Common Response 6.1

Sacramento Water Allocation Model and Changes in Hydrology and Water Supply

Figure CR 6.1-1. Annual Total Supply from Putah Creek for Baseline, 55 w/WSAs and 55 Scenarios

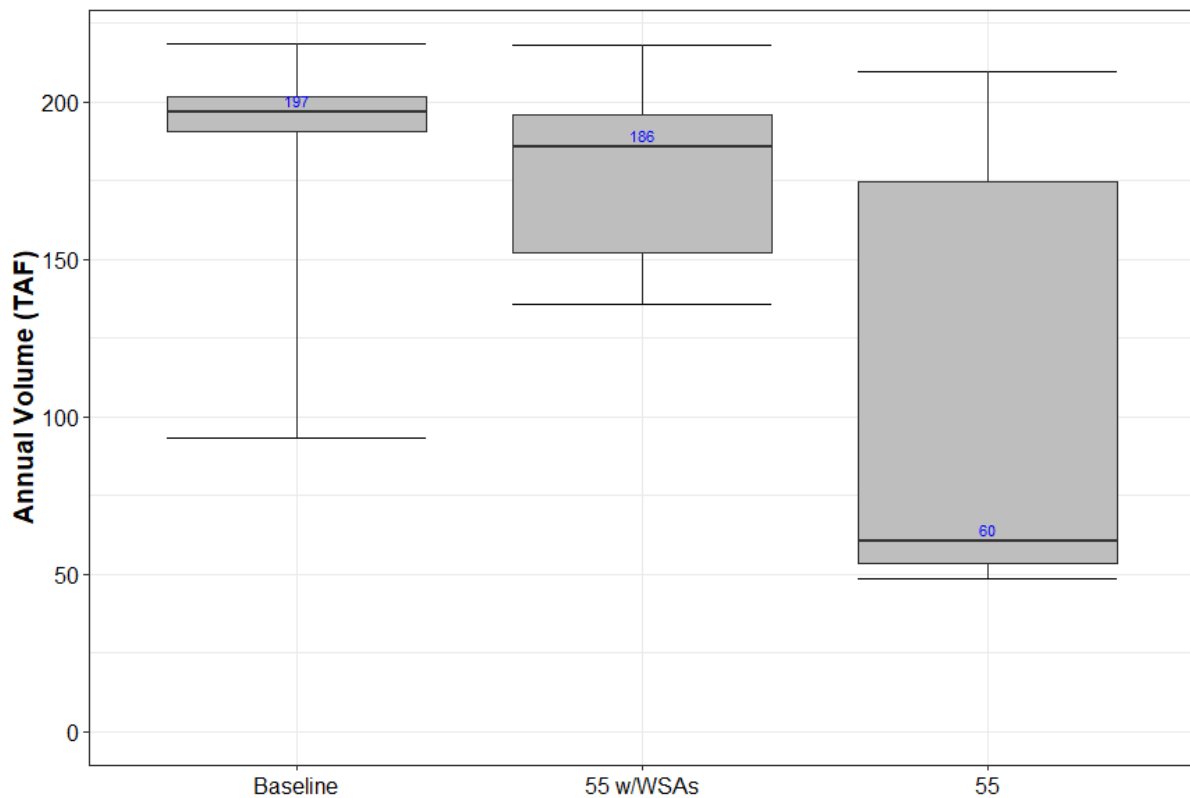
Suisun-Solano Water Authority (SSWA) asserts in comments that their independent evaluations of the modeling assumptions in Chapter 13, *Revised Proposed Plan Amendments*, demonstrated that the 55 w/WSAs scenario would result in zero water deliveries to SSWA in 10 percent of years under the low carryover storage requirement. SSWA did not provide any details on how their analysis was performed, however SacWAM results show much smaller reductions in water supply in the 55 w/WSAs scenario. Figure CR 6.1-1 shows that there are no years when the supply is reduced below 125 TAF per year under the 55 w/WSAs scenario and Table CR 6.1-1 shows that the average annual reduction for the 55 w/WSAs scenario is 20 TAF or 10 percent from baseline. The maximum reduction appears to occur most often in below normal water year types when the relaxation to the flow requirements may not have triggered. These reductions are dispersed throughout the time period, not all occurring in sequence and thus there are periods of recovery between periods of intermittent delivery reductions. Considering the lower magnitude in delivery reductions and the dispersed nature of the reductions, it is likely member agencies could work cooperatively together to reduce the impacts to any one city. There are also provisions in the revised proposed Plan amendments for development of curtailment exceptions for human health and safety needs to reduce impacts from extreme conditions.

Figure CR 6.1-4. Comparison of SacWAM Existing Conditions Simulated Storage and Historical Observed Storage for Camanche Reservoir. Source: SacWAM version 2025.08.28 and CDEC 2026.

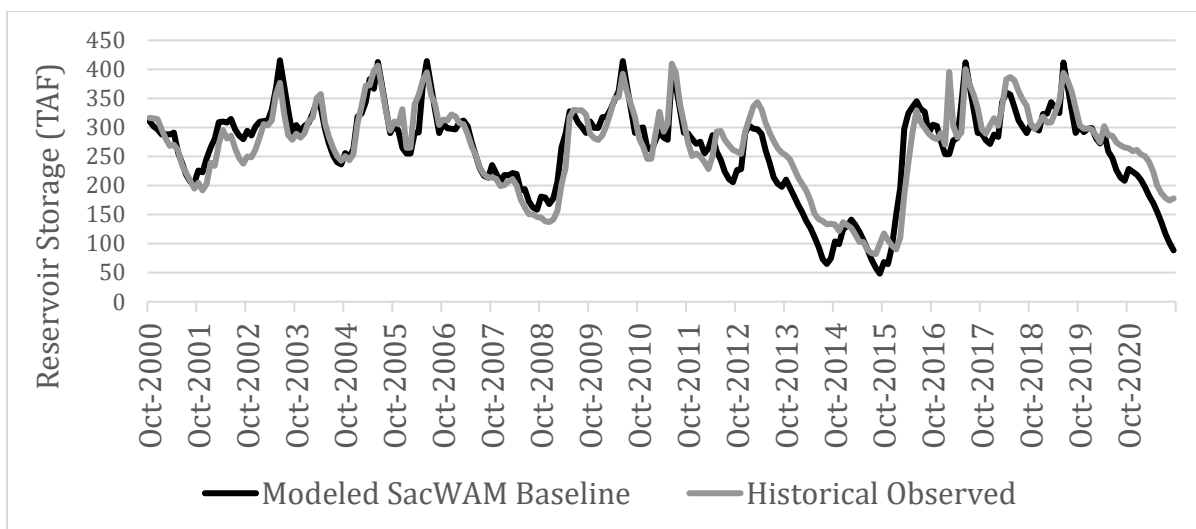
The Board received multiple comments by EBMUD contending that because SacWAM does not match their model, EBMUDSIM, SacWAM is flawed, and that the Staff Report should rely on EBMUDSIM instead. Comments asserting that inter-model comparisons show SacWAM poorly representing historical operations do not hold merit because such arguments assume that EBMUDSIM perfectly represents historical operations, yet EBMUD did not provide any comparisons of EBMUDSIM or SacWAM to historical observations to support this assertion. As referenced above, when SacWAM is compared with recent historical observations, its simulation results align well with historical reservoir storage, diversions and streamflows (see below for an example of recent historical storage and modeled baseline storage for Camanche Reservoir using SacWAM). The Nash-Sutcliffe model efficiency metric for the Camanche Reservoir storage shown in Figure CR 6.1-4 is 0.79 (out of a maximum value of 1.0), which indicates a very strong match between SacWAM results and observed historical data. Differences in model results between SacWAM and EBMUDSIM could be explained by differences in model assumptions (EBMUDSIM's assumptions were not provided) or inaccuracies in EBMUDSIM. Regardless, the fact that SacWAM results depicting existing conditions do not match EBMUDSIM results does not mean SacWAM is flawed or that it is an inappropriate tool to analyze the impacts of the update of the Bay-Delta Plan.

Even if EBMUDSIM were found to outperform SacWAM by more accurately representing the details of the EBMUD system, EBMUDSIM would not be an appropriate tool for use in the Staff Report, as it only simulates EBMUD’s water delivery system and a portion of the Mokelumne River. The study area for the Bay-Delta Plan update covers a large portion of California (see Figure 1-1c in Chapter 1, *Executive Summary*, of the Staff Report). As discussed earlier in this common response, State Water Board staff and consultants developed SacWAM to be a flexible model capable of representing a range of alternatives and analyzing impacts in the plan area and to inform analyses throughout the entire study area.
